Addendum No. 1

Project: Smith Field Airport
Construct Taxilane
AIP No. 3-18-0024-028-2025
AIP No. 3-18-0024-029-2025

CHA Project No.: 092686.000

Date: June 06, 2025

OVERALL CONSTRUCTION SAFETY AND PHASING PLAN

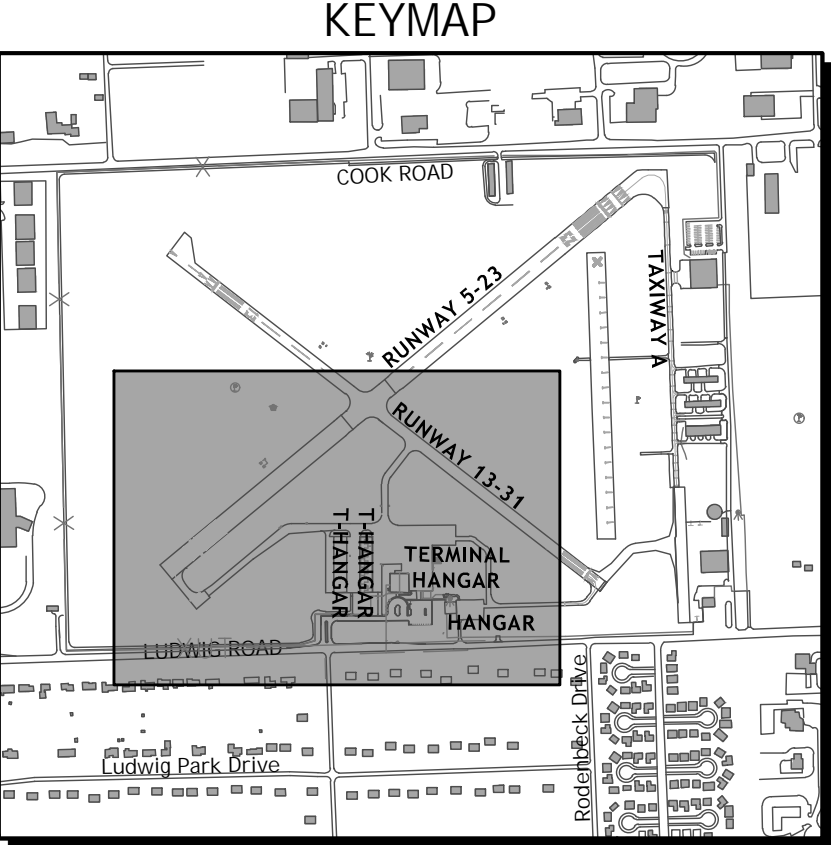
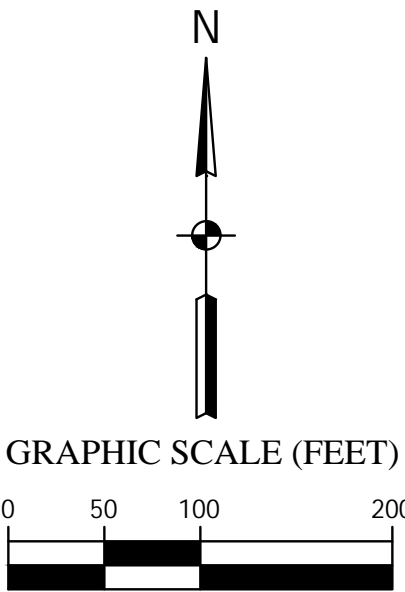
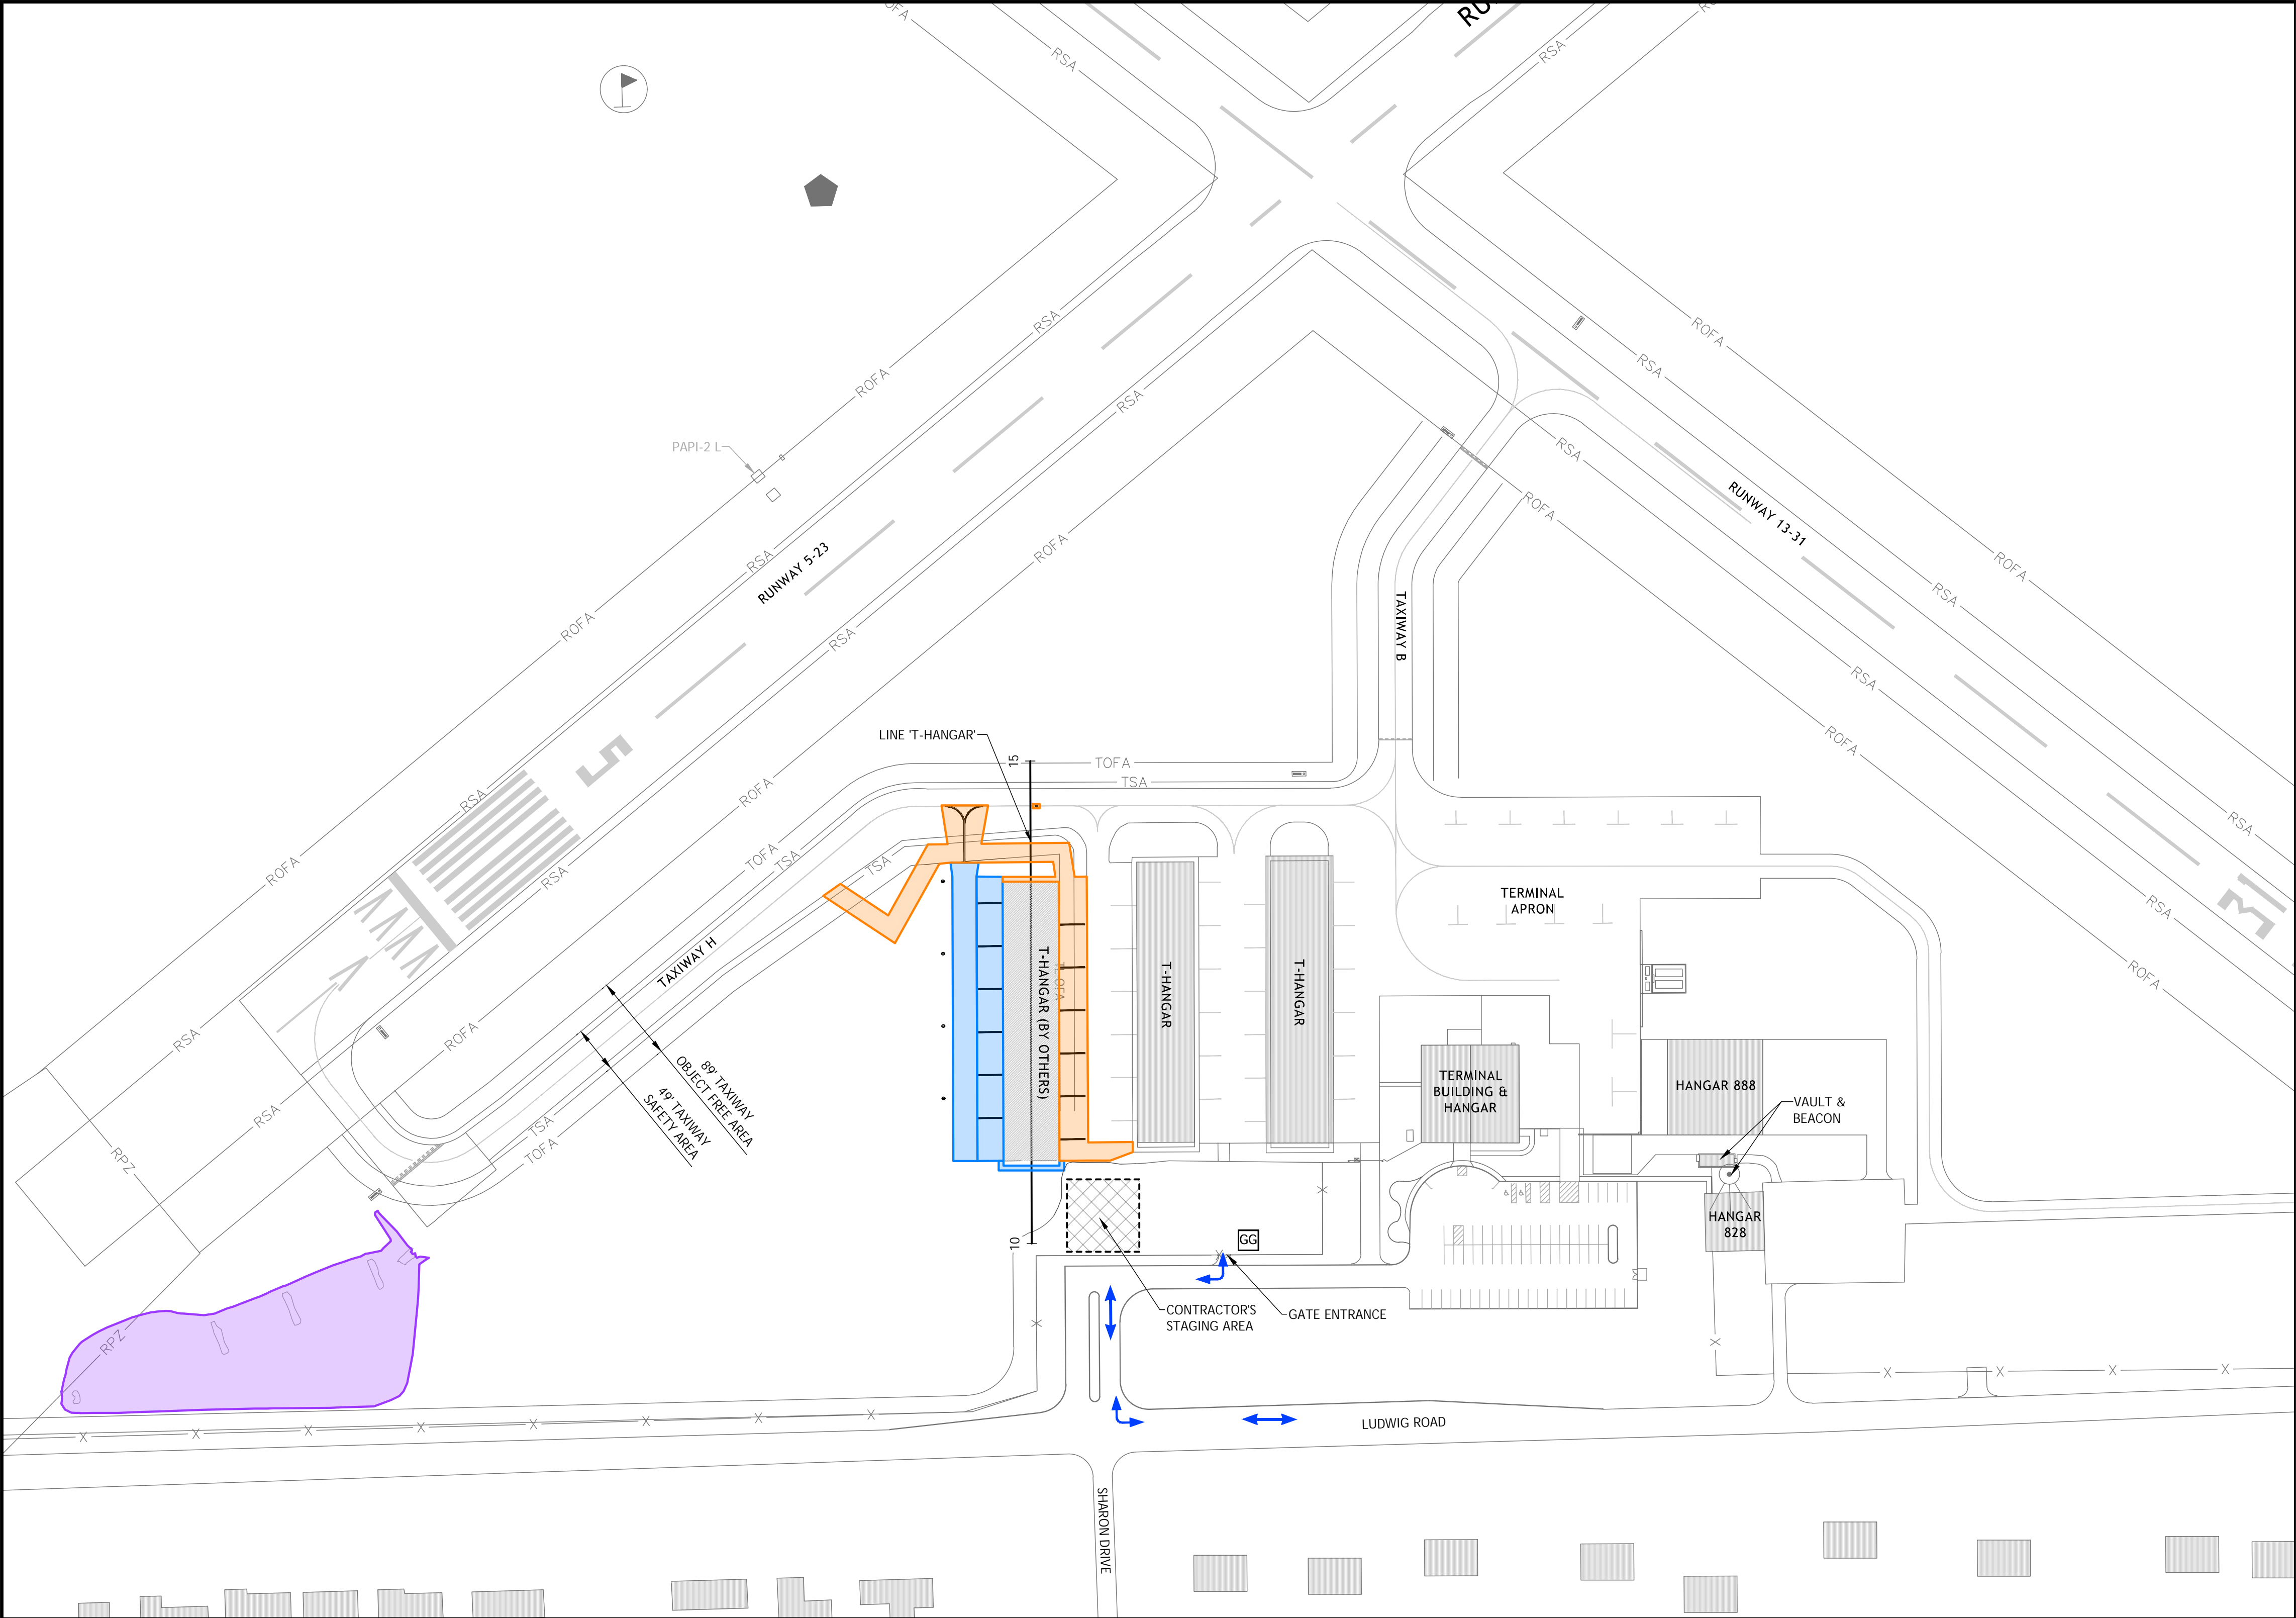
Sheet 9 – Overall Construction Safety and Phasing Plan

Reissued: Due to various changes this sheet has been reissued in its entirety.

CONSTRUCT TAXILANE			FORT WAYNE, IN		
GRADING AND DRAINAGE PLAN			SMITH FIELD (SMD)		
SHEET 1 OF 2					
DESIGNED BY: EJW			DRAWN BY: KDR		
ISSUE DATE: 5/28/2025			PROJECT NO: 092686		
CHECKED BY: NSB			SCALE: AS SHOWN		
DRAWING NO.: 19

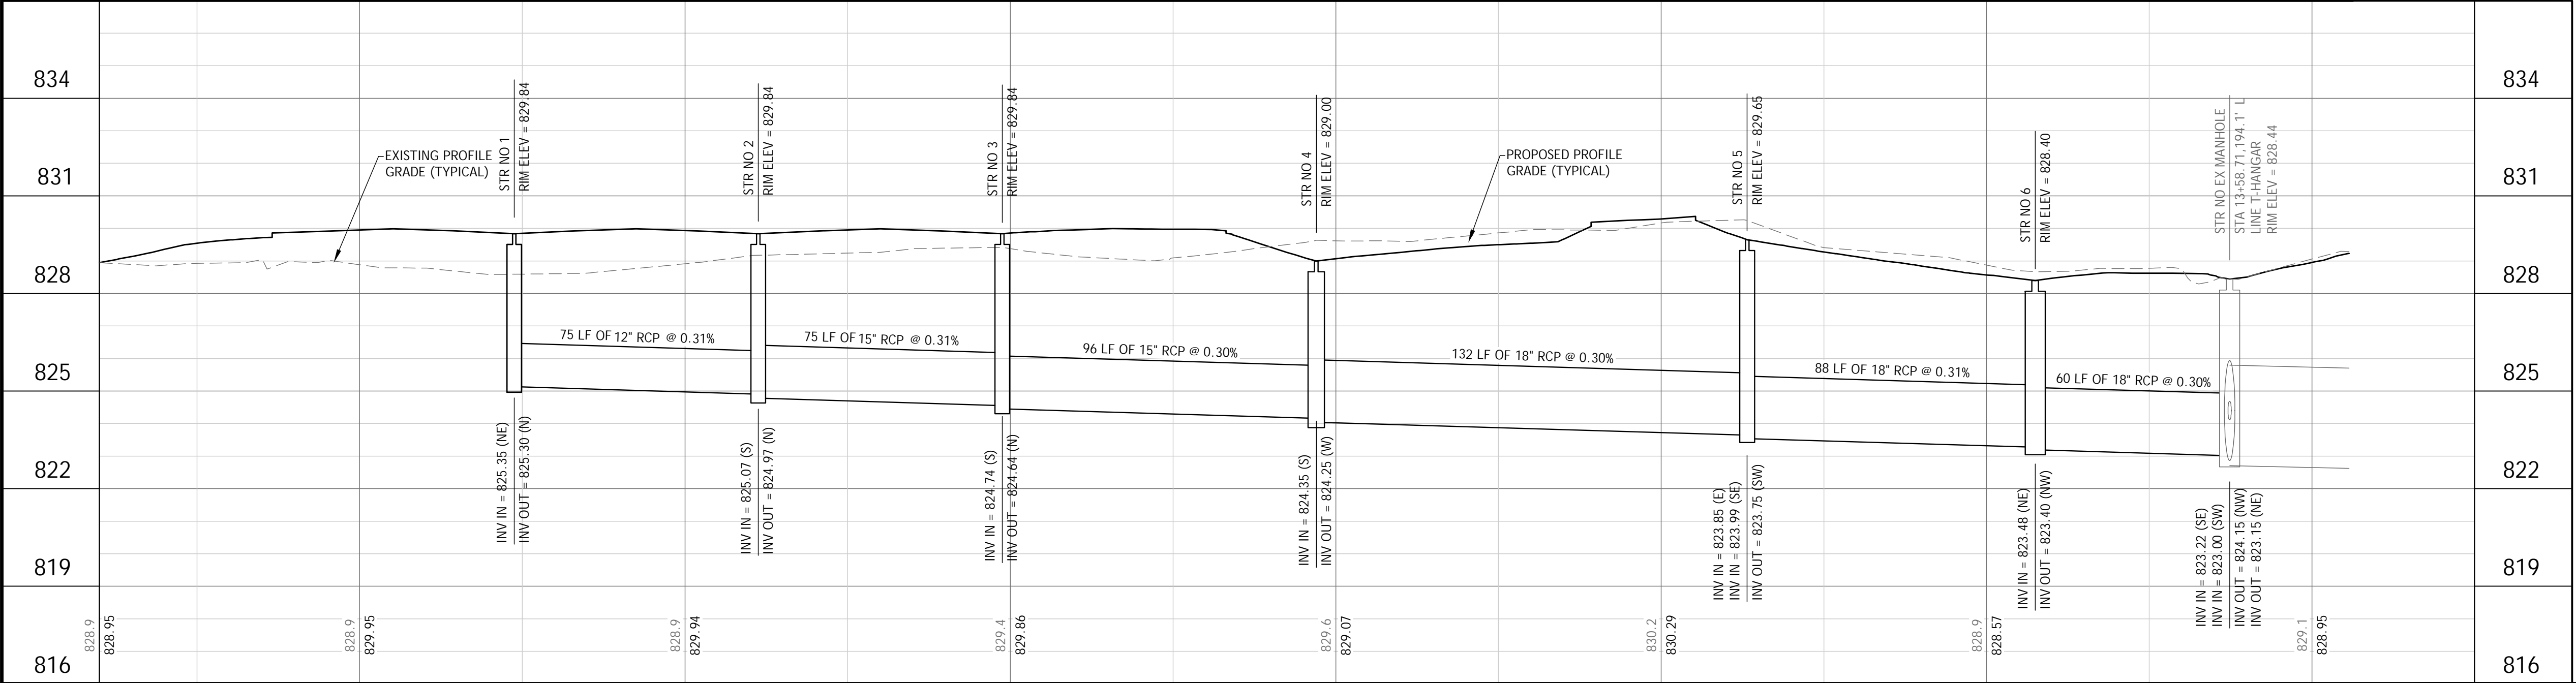
Sheet 19 – Grading and Drainage Plan Sheet 1 of 2

Reissued: Due to various changes this sheet has been reissued in its entirety.
